Memorandum

RE: Other Business for the December 10, 2020 Planning Commission Meeting

This memo is to provide background for the Planning Commission to consider as a part of the Other Business to be reviewed during the December 10, 2020 Planning Commission meeting.

PRELIMINARY - SITE PLAN

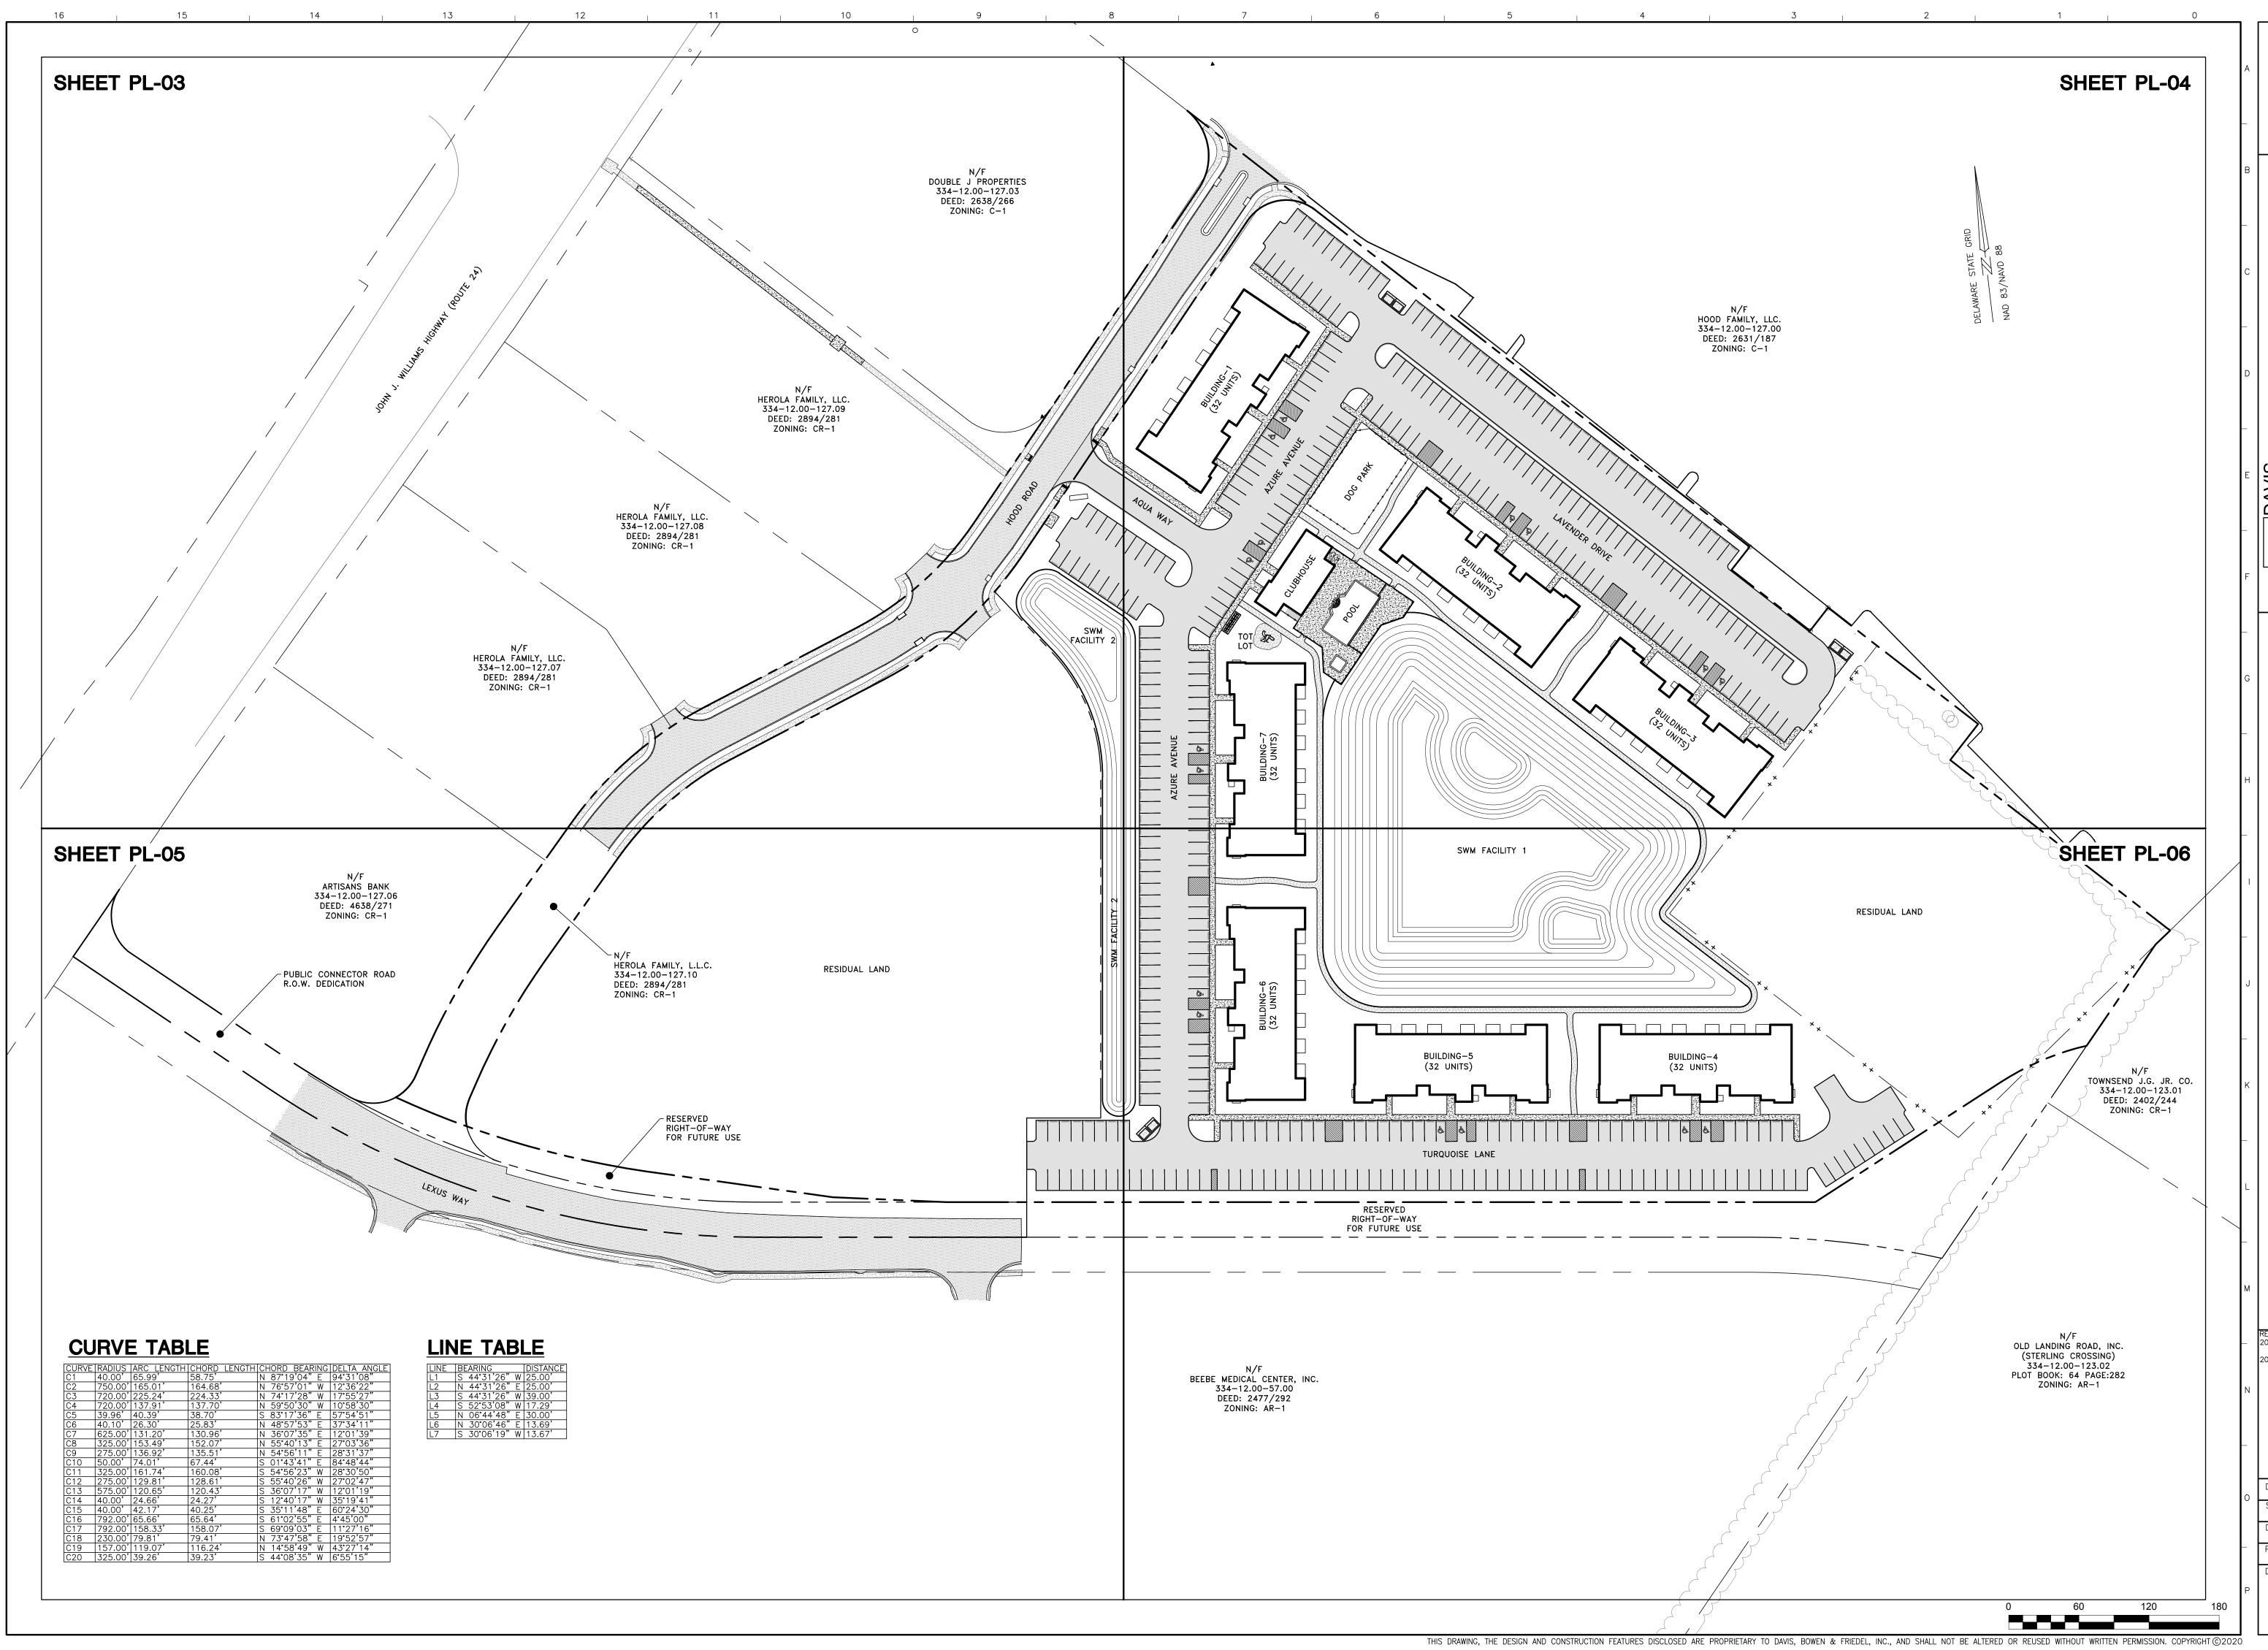
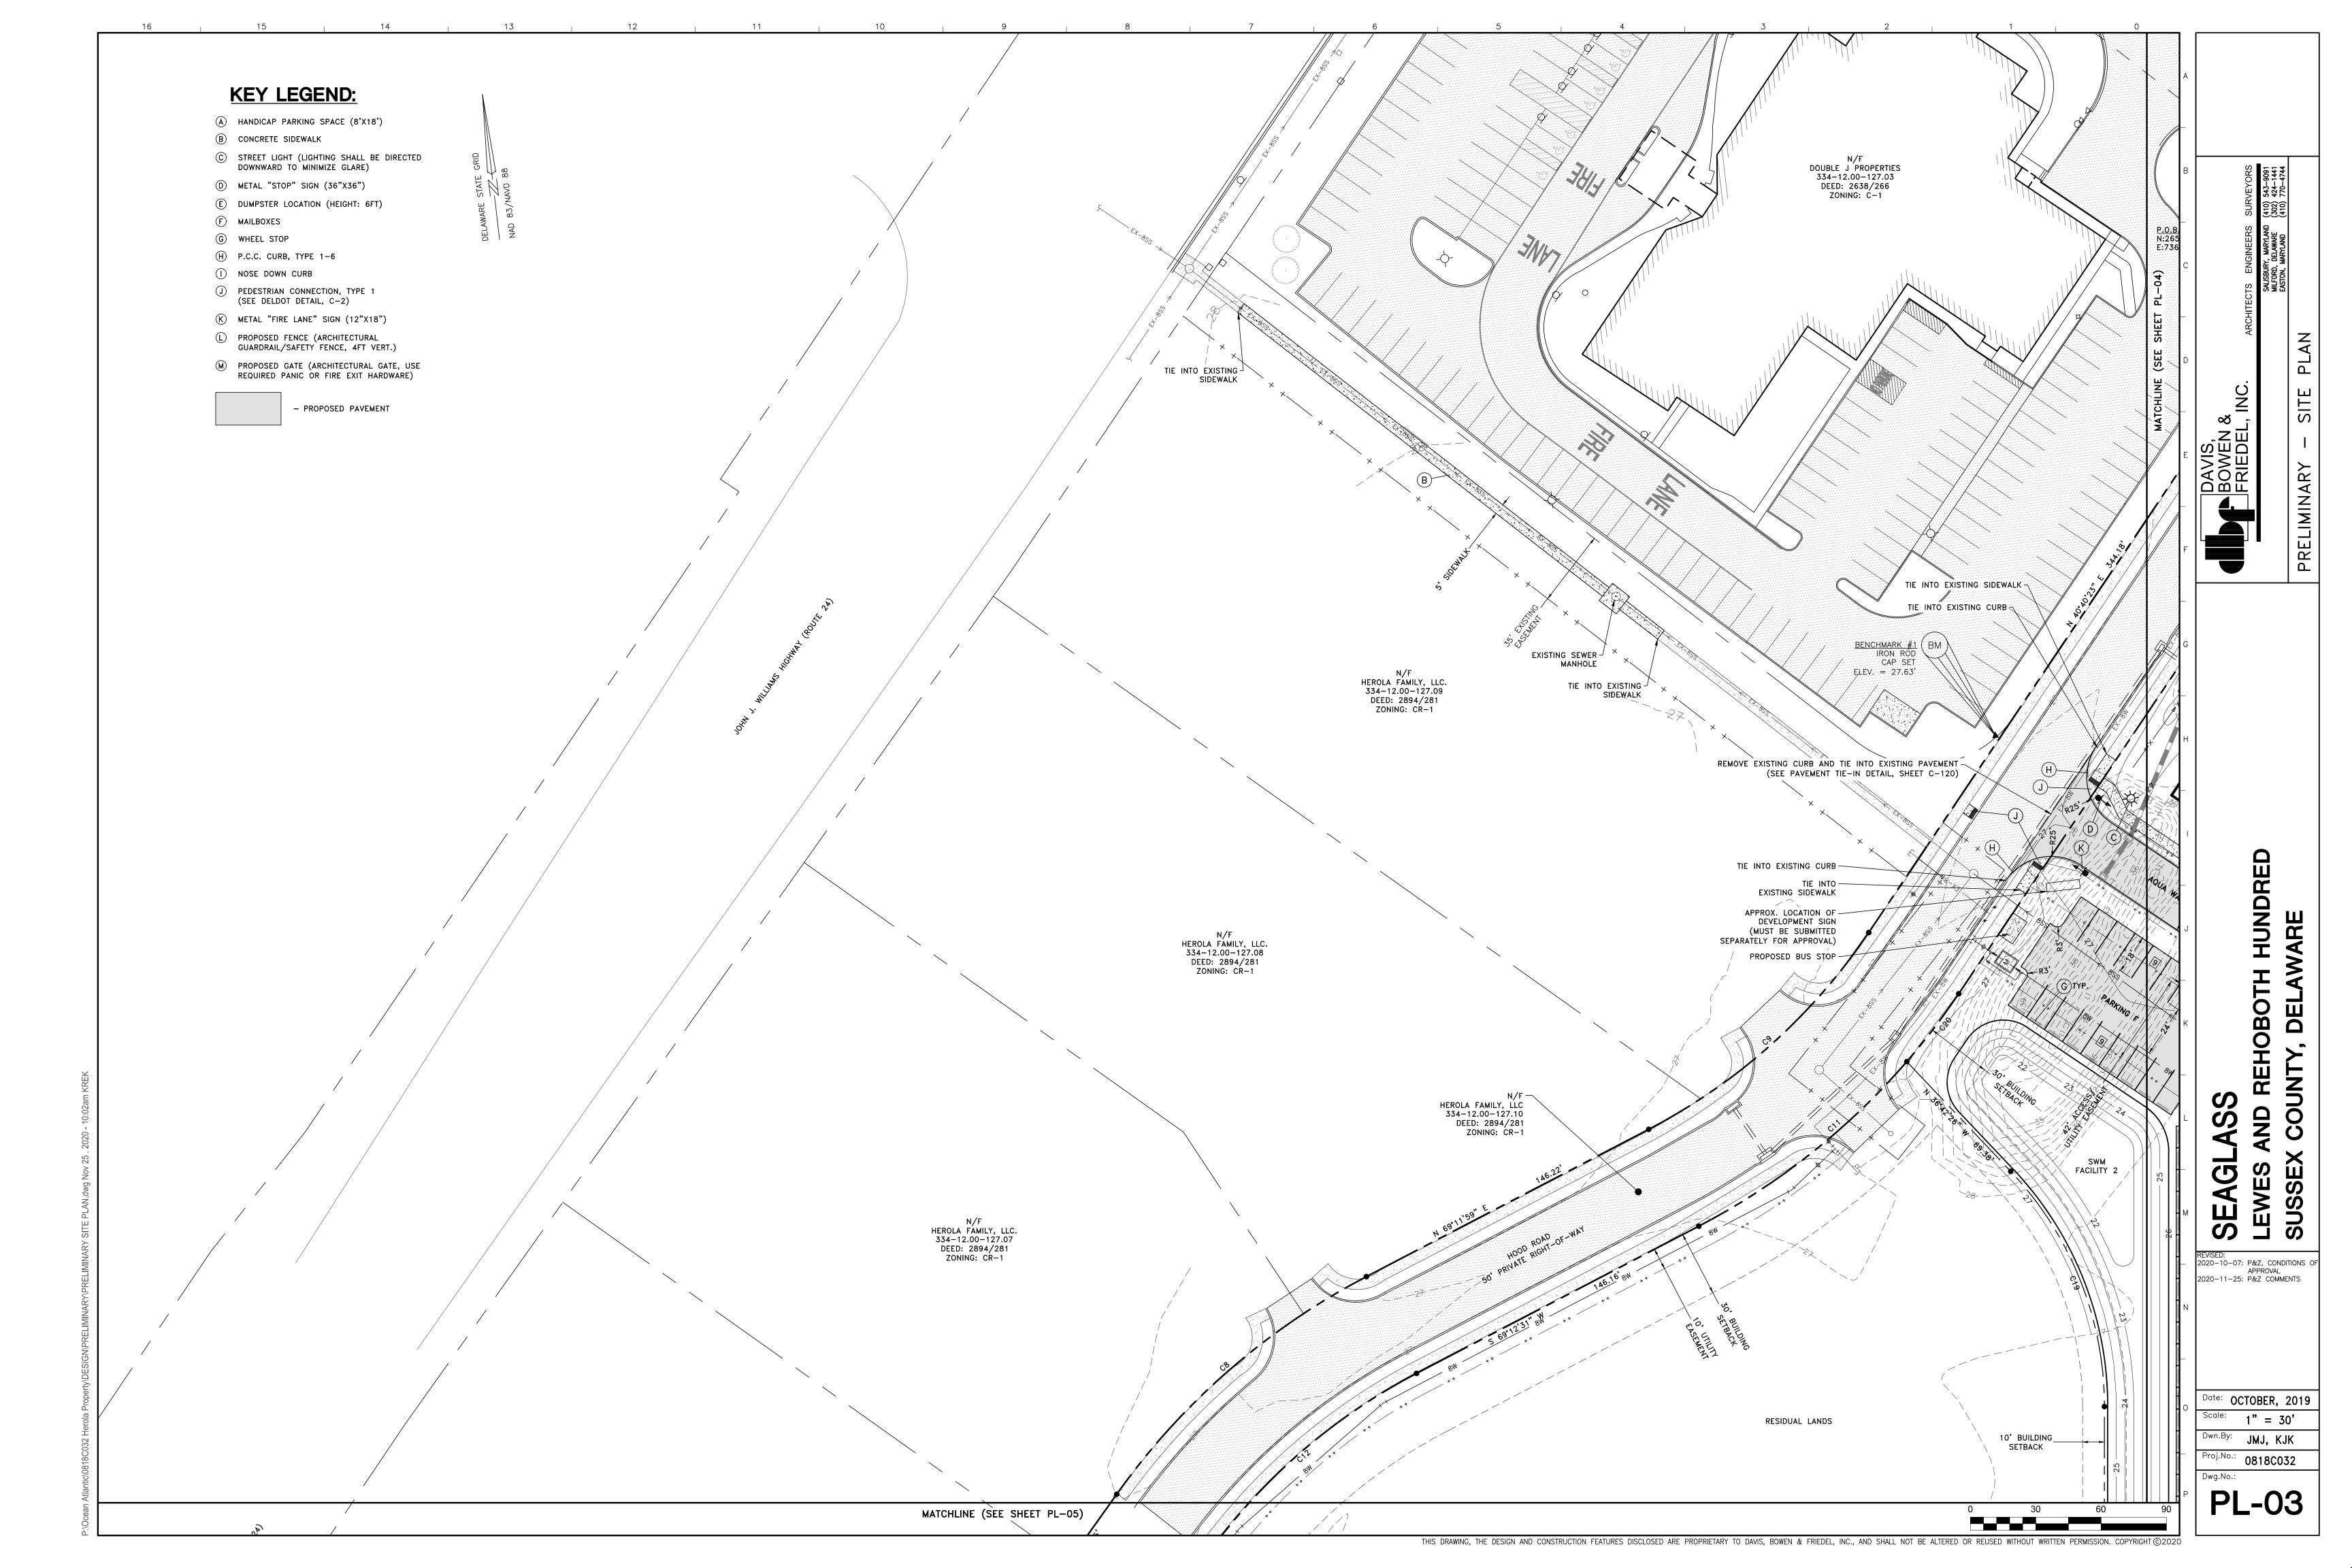
This is a Preliminary Site Plan for a proposed 224-unit multi-family apartment complex to consist of a clubhouse, pool, dog park, tot lot, 448 parking spaces and other site improvements located on 18.759 acres +/-. The property is located directly east of John J. Williams Hwy (Route 24) just south of Coastal Highway (Route 1). The applicant is seeking relief for 74 parking spaces to be located within the front setback of a private right of way. The Preliminary Site Plan otherwise complies with the Sussex County Zoning Code. Tax Parcel: 334-12.00-127.01 & 127.10. Zoning: CR-1 (Commercial Residential Zoning District). Staff are awaiting agency approvals.
